DEVELOPMENT REVIEW COMMITTEE (DRC) COMMENT REPORT

**Project Name: Redus Florida Commercial LLC / Dunkin Donuts
at Corporate Drive**

Case Number: R15031

**Request: Site Plan Level II Review: 1858sf Restaurant Use
within 300 feet of Residential Property**

1 SOUTH ELEVATION

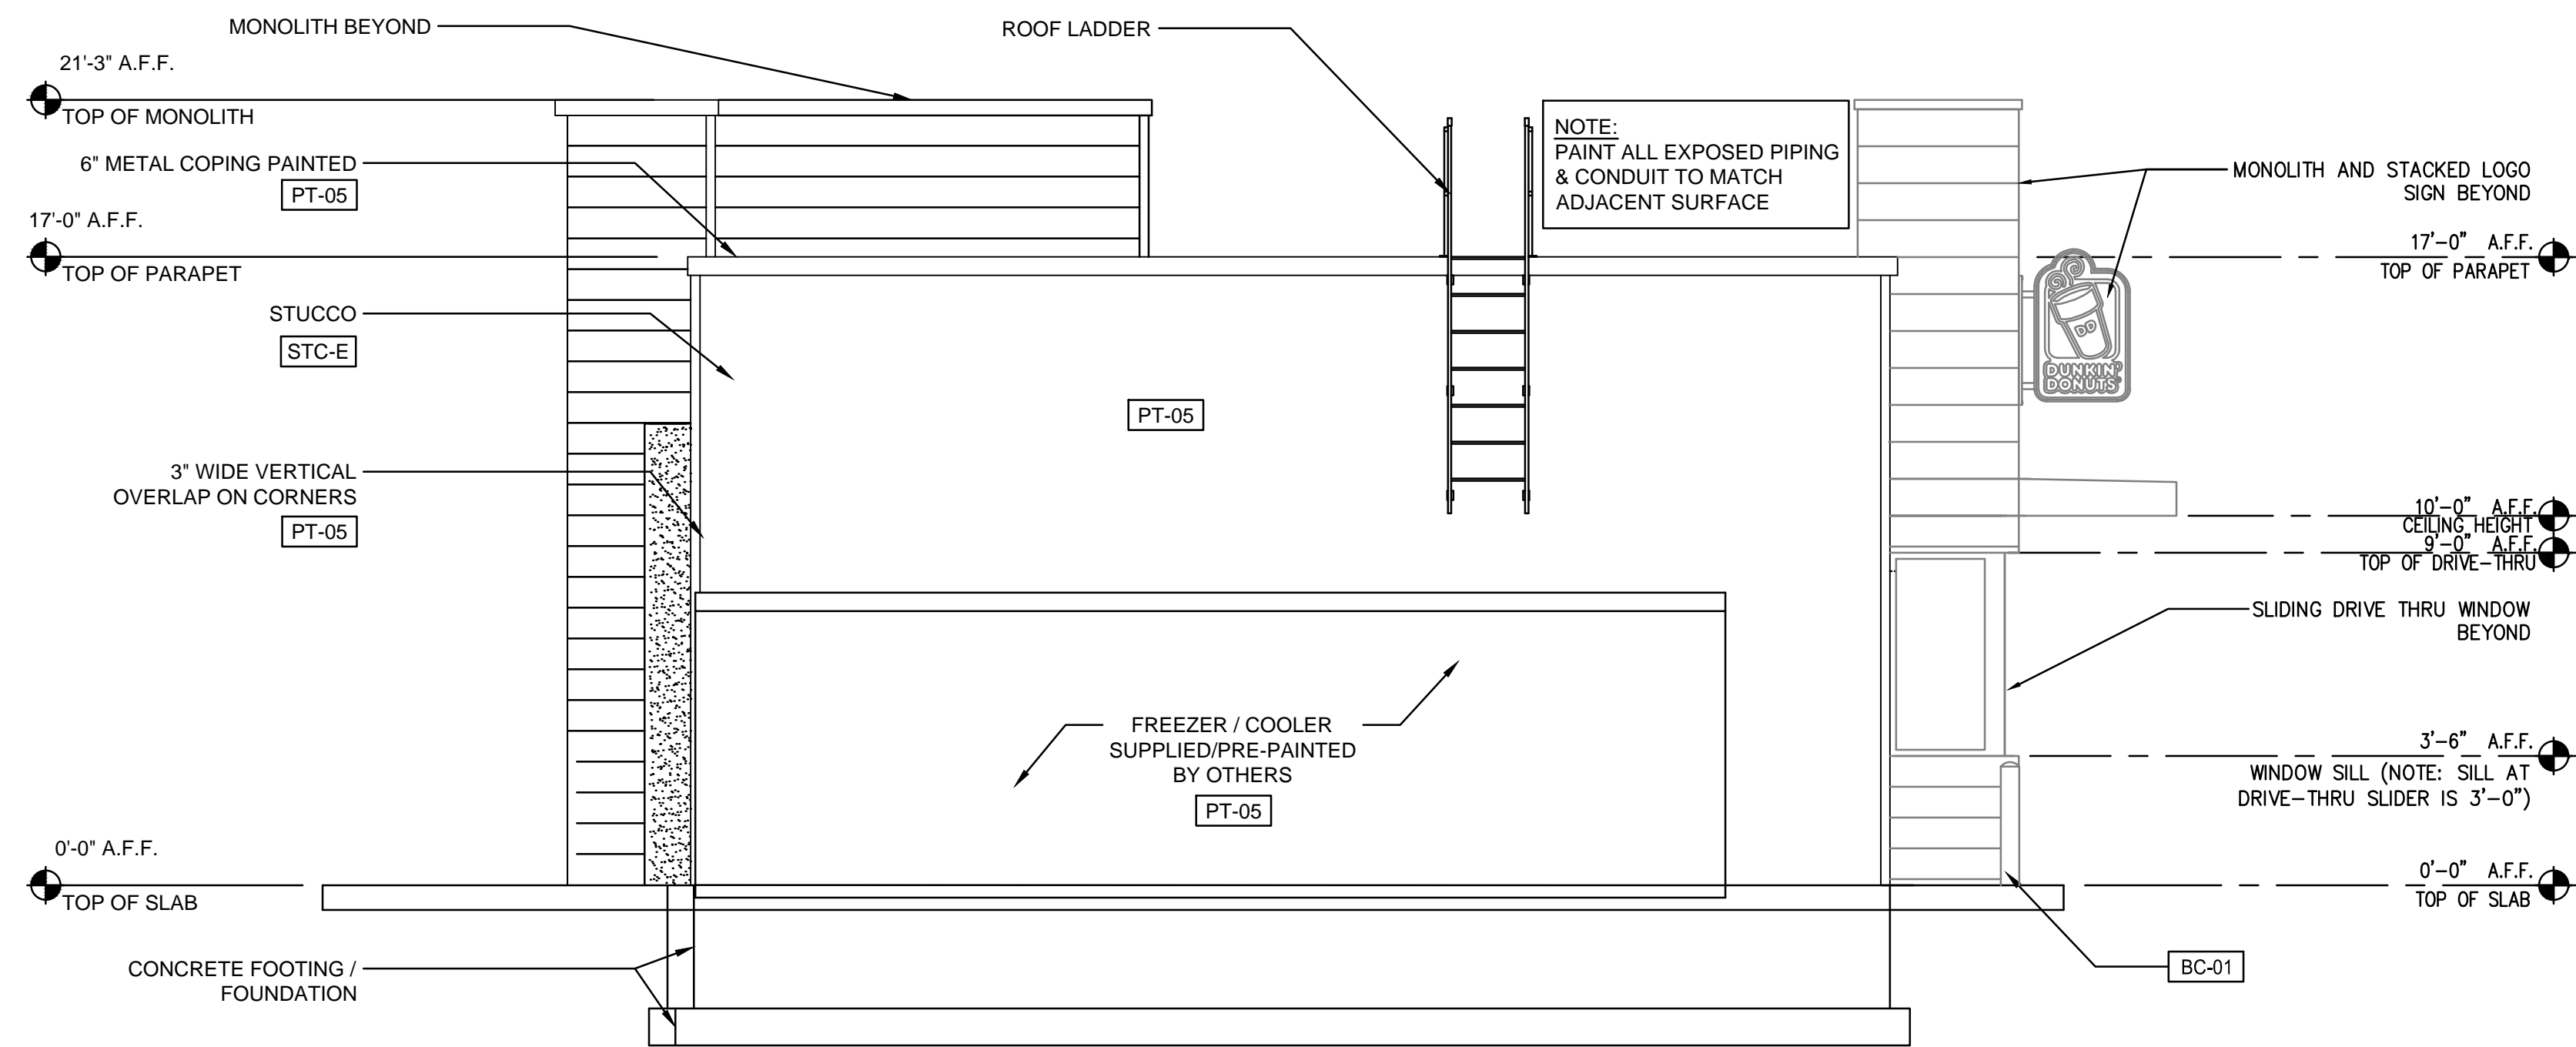
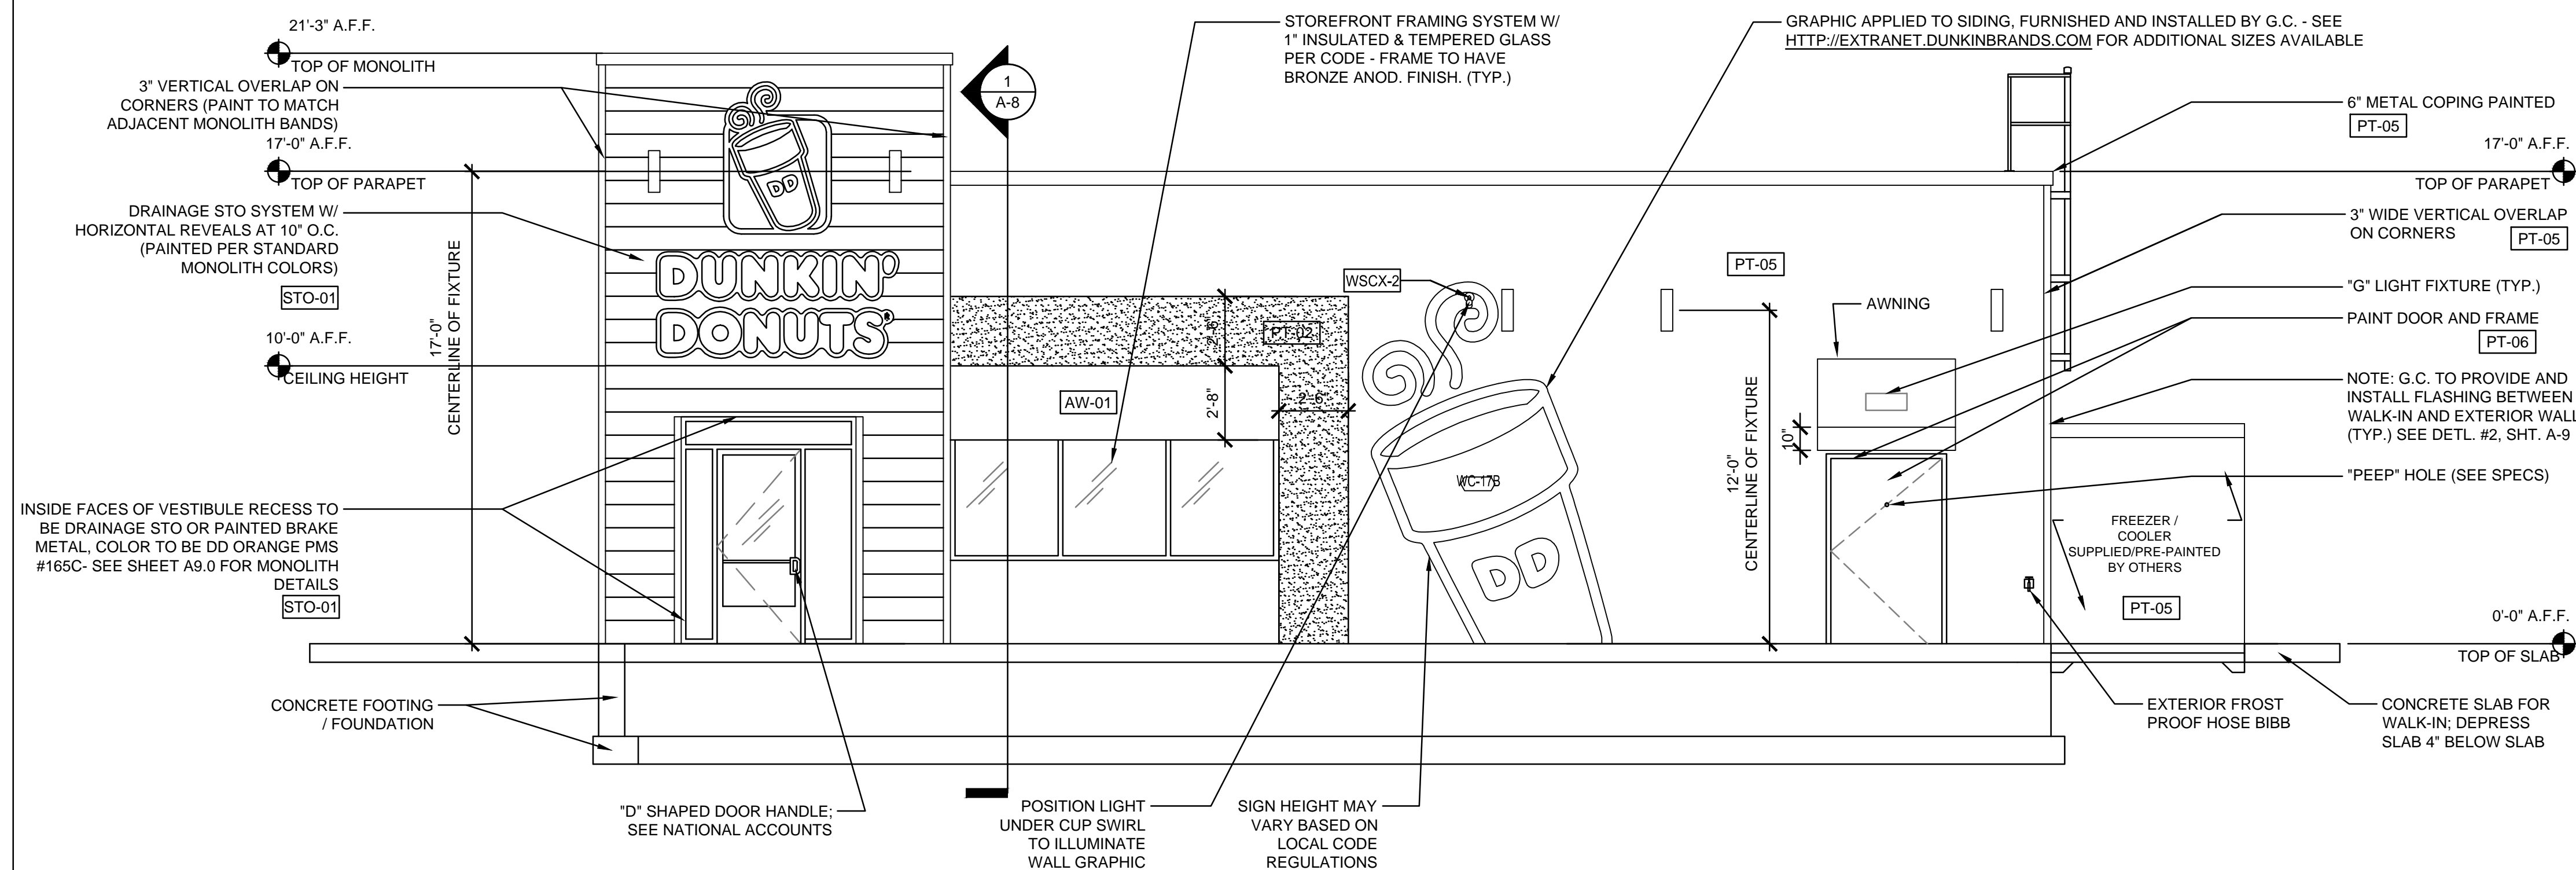
- d. Relocate the outdoor seating area to the front yard, along NE 62nd Street, to activate the use along the street.
- 6) The South elevation, facing NE 62nd Street, lacks architectural details. Improve the design of the facade to allow for wider openings facing the street and more appealing architectural details, color and articulation.
